NOTICE OF ADDENDUM

ADDENDUM NO. 1

CONTRACT NO. 6926

PARK STREET, FISH HATCHERY INTERSECTION IMPROVEMENTS

PLAN OF PROPOSED IMPROVEMENT

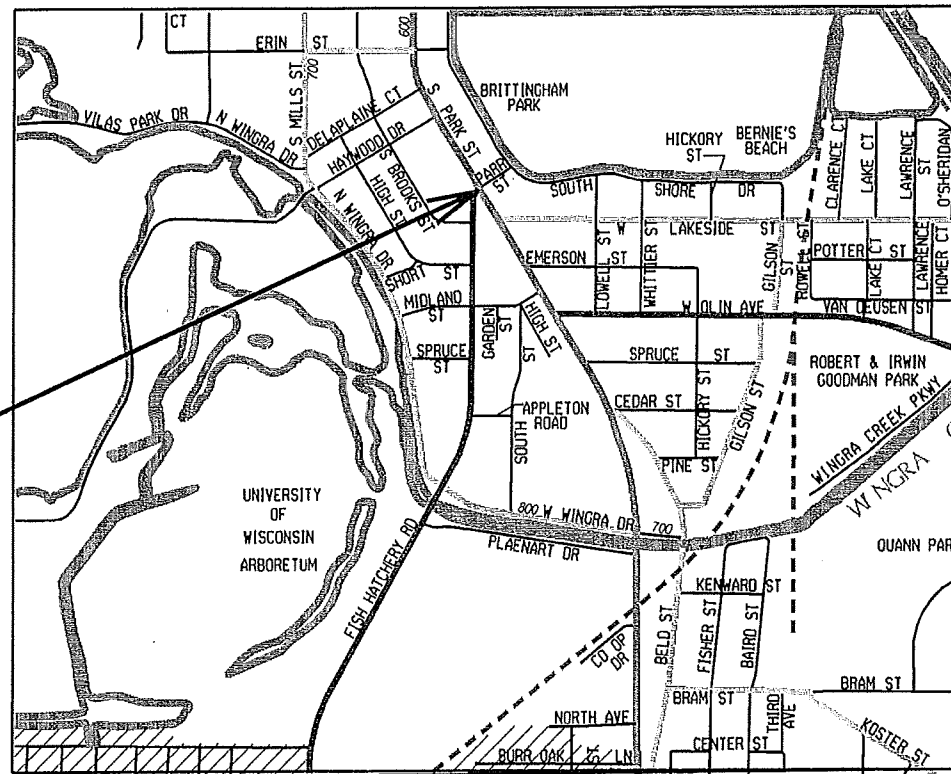
REMOVE TITLE SHEET

& REPLACE TITLE SHEET (DATED 8/3/12)

Printed title sheet in plan set available at Emil Street was incorrect (Earthwork Quantities were incorrect and no stamps/signatures were provided). Title sheet available on city website was correct.

EARTH WORK SUMMARY:
EXCAVATION CUT (MEASURED PLAN QUANTITY)..... 40 C.Y.
